Access Compliance Report

Public Rights-of-Way

Intersection ID: N/A	Main Street: N_TRYON_ST	Cross Street: HAMPTON_CHURCH_RD	Location: SE
ADA ID: BD54E8FD5746	Ramp Type: PerpDiag	Initial Pass/Fail: Fail	Overall Compliance: No
		Severity Score: 33.75

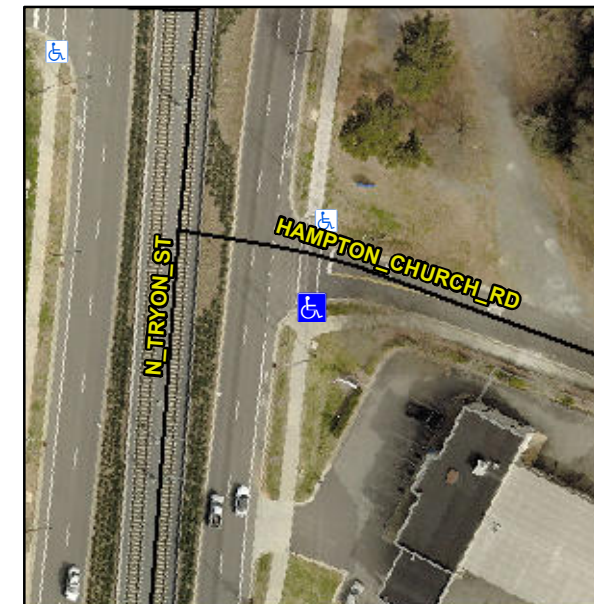
R304.5.1, R304.2.2, R304.5.3

Compliance	Description	Data	Compliance	Description	Data
N/A	Ramp Length (in)	88.0	No	Ramp Slope (%)	9.1
No	Ramp Width (in)	46.5	No	Ramp XSlope (%)	5.6
N/A	Flare Type LT	N/A	N/A	Flare Type RT	N/A
N/A	Flare Slope LT (%)	N/A	N/A	Flare Slope RT (%)	N/A
N/A	Flare Traversable LT?	N/A	N/A	Flare Traversable RT?	N/A
N/A	Landing Length (in)	N/A	N/A	DWS Provided?	N/A
N/A	Landing Width (in)	N/A	N/A	DWS Contrast?	N/A
N/A	Landing Slope (%)	N/A	N/A	DWS Length (in)	N/A
N/A	Landing X Slope (%)	N/A	N/A	DWS Full Width?	N/A
N/A	Landing Curb? (Y/N)	N/A	N/A	DWS Offset (in)	N/A
N/A	Shared Landing?	N/A			
N/A	Gutter Ponding?	N/A	N/A	Gutter Slope (%)	N/A
N/A	Gutter Lip Ht (in)	N/A	N/A	Gutter X Slope (%)	N/A
N/A	Painted X Walk1?	Yes	N/A	Painted X Walk2?	No
	X Walk 1 Direction	To N		X Walk 2 Direction	To W
N/A	X Walk 1 Width (in)	111.0	N/A	X Walk 2 Width (in)	N/A
	X Walk 1 Slope (%)	0.8		X Walk 2 Slope (%)	3.9
	X Walk 1 X Slope (%)	3.8		X Walk 2 X Slope (%)	0.1

Remove & Replace Curb Ramp With Two New Directional Ramps or Equivalent.
